Rezoning Application: PD 26-0422
Zoning Hearing Master Date: June 22, 2026
BOCC CPA Hearing Date: August 13, 2026

The applicant requests a Planned Development rezoning for approximately 190 acres located along Lithia Pinecrest Road. The proposal would establish a unified Planned Development allowing up to 280 single-family detached homes. The request is accompanied by a related Comprehensive Plan Amendment to bring the property into the Urban Service Area and change the Future Land Use designation from Agricultural Rural to Residential-2 (CPA 26-05 and 26-06). The Planned Development consolidates multiple parcels under a single zoning entitlement and organizes residential lots within the interior of the site. Perimeter areas include landscape easements, open space, and wetland conservation areas as delineated on the plan.

AGENCY REVIEW COMMENT SHEET

2.4 Proposed Site Plan (partial provided below for size and orientation purposes. See Section 8.0 for full site plan)

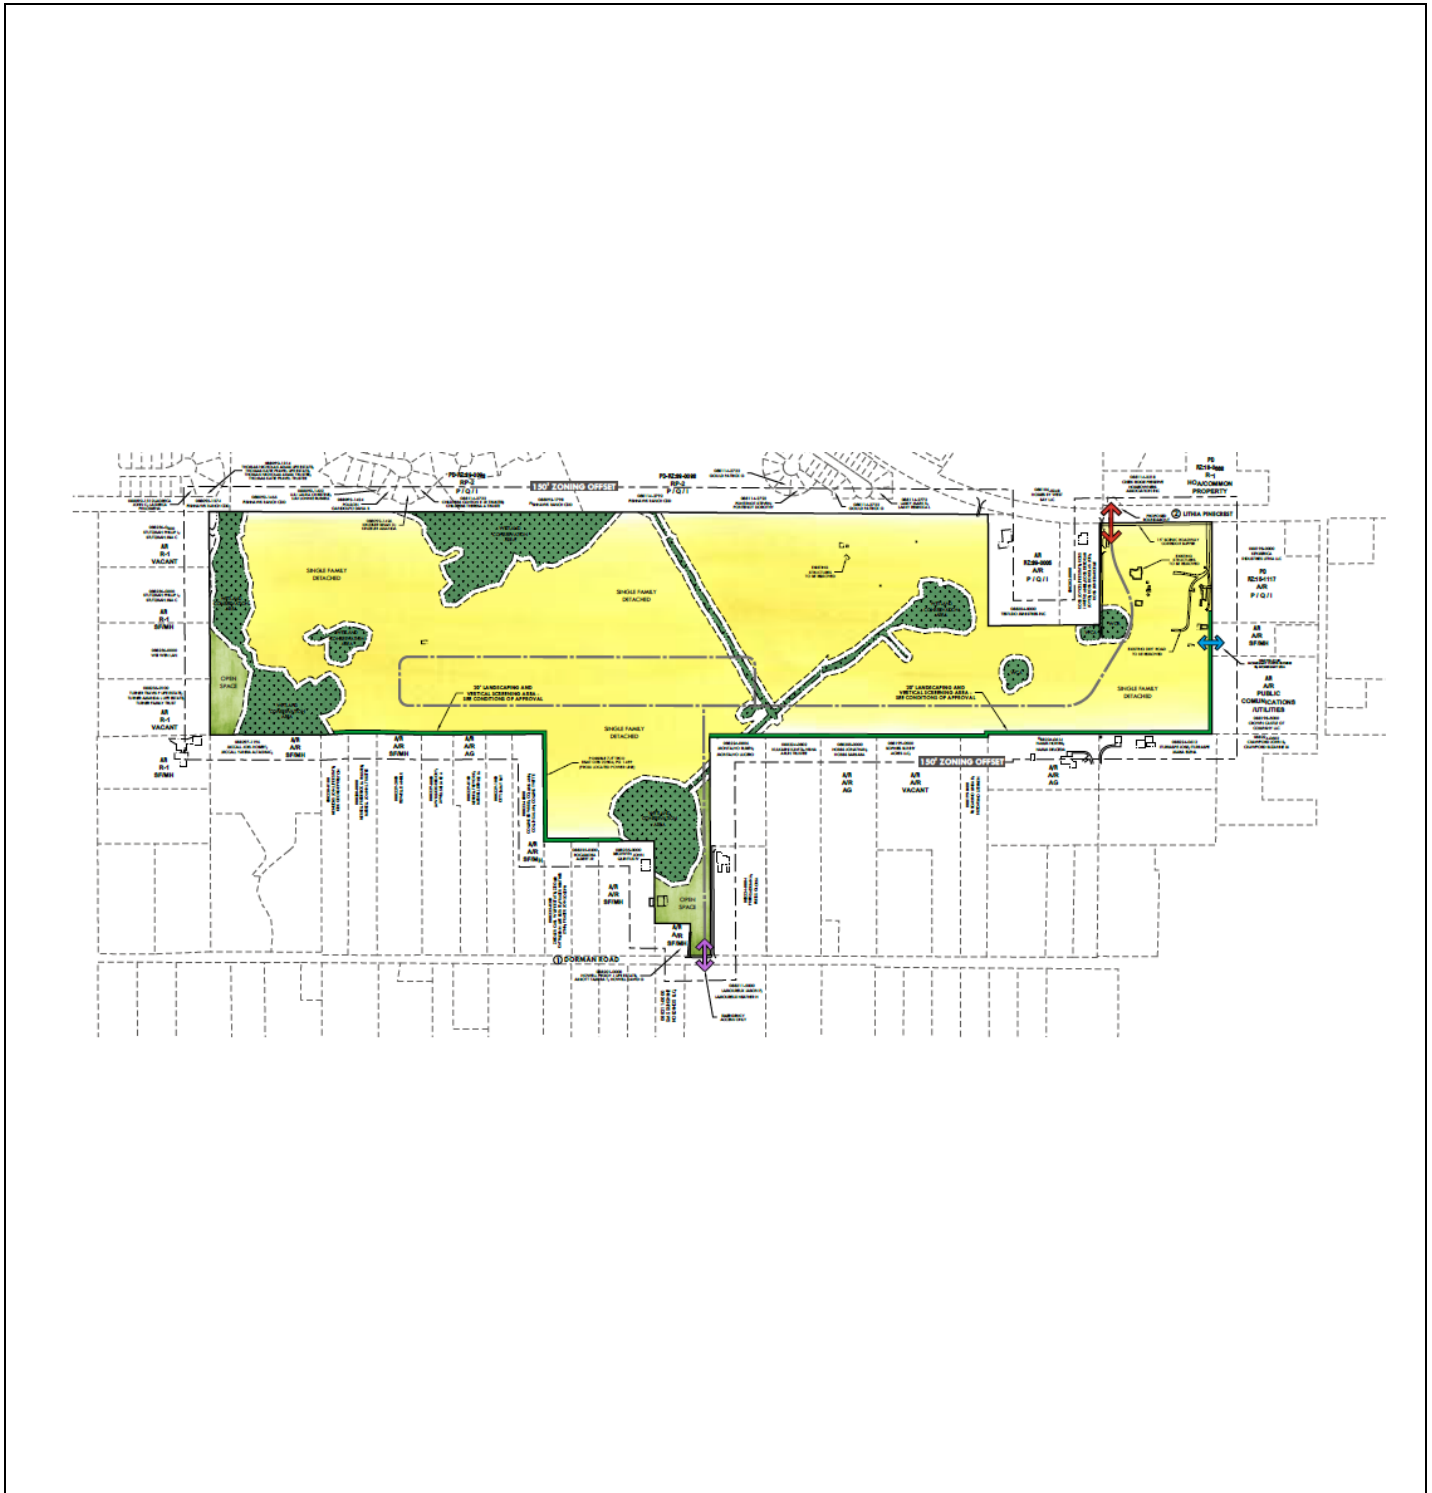
Prior to PD Site Plan Certification, the developer shall revise the site plan received April 8, 2026 to:

1. Be shown in black and white.
2. Meet the Development Review Procedures Manual (DRPM) minimum requirement specifying the project show the “points of ingress and egress and/or driveways and curb-cuts” within 150 feet of the project boundaries, as well as show those driveways outside of the 150-foot area that are otherwise the subject of an access spacing variance.

3. Replace the last sentence of Note 12 with a note stating, “All existing access connections to be closed/removed and resodded.”
4. Revise the Dorman Road access data table to state the minimum and maximum extents of right-of-way width variance and show those locations on the site plan.

5. Revise the Lithia Pinecrest Road access data table to:
 - a. State the minimum and maximum extents of right-of-way width variance and show those locations on the site plan;

- b. Correct the “+/- 24’ asphalt pavement” width notation to instead state “+/- 11 to 12-foot-wide asphalt lanes”; and,
 - c. Remove “bike path” from the list of not present facilities and instead add a new bullet stating “+/- 5-foot-wide bicycle facilities (on paved shoulders). Staff notes that on rural roadways paved shoulders typically provide bicycle access in lieu of bicycle lanes or buffered bicycle lanes on urban sections.

FIGURE 1
ACCESS SPACING

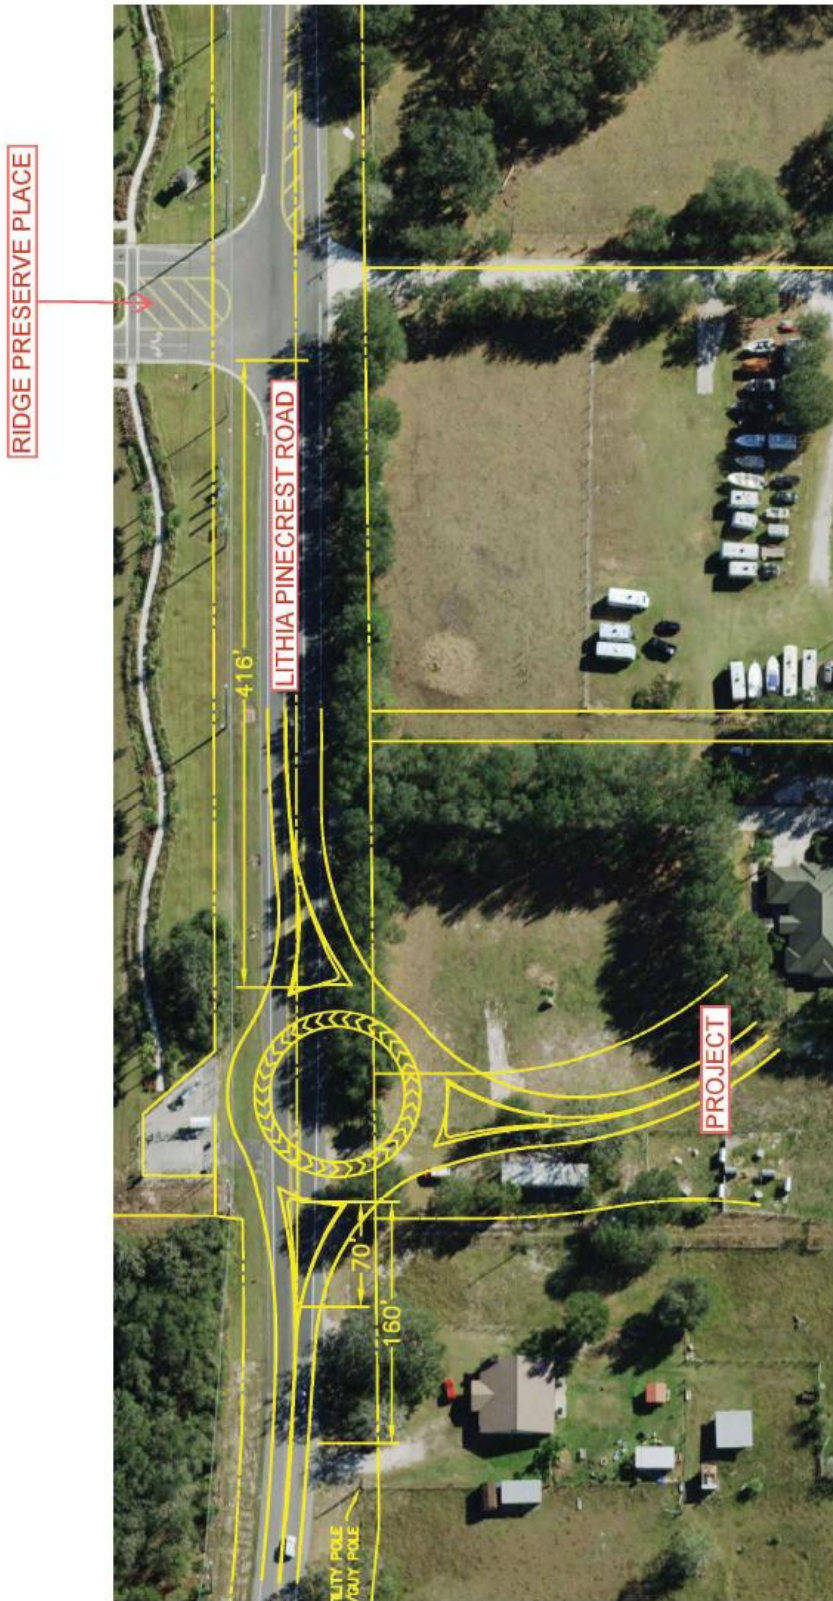
The request is for an Administrative Variance to Section 6.04.07 of the Hillsborough County LDC for the access spacing on Lithia-Pinecrest Road. Based on Section 6.04.07, Lithia-Pinecrest Road is classified as an Access Class 3 roadway with an access spacing of 330 feet. The property to the west has two (2) driveways, the spacing to the western most driveway is 160 feet and 70 feet to the eastern driveway. In addition, spacing is approximately 416 feet to Ridge Preserve Place to the east. This is graphically shown in Figure 1.

The attached administrative variance is **Approvable** to me. Please include the following people in your response:
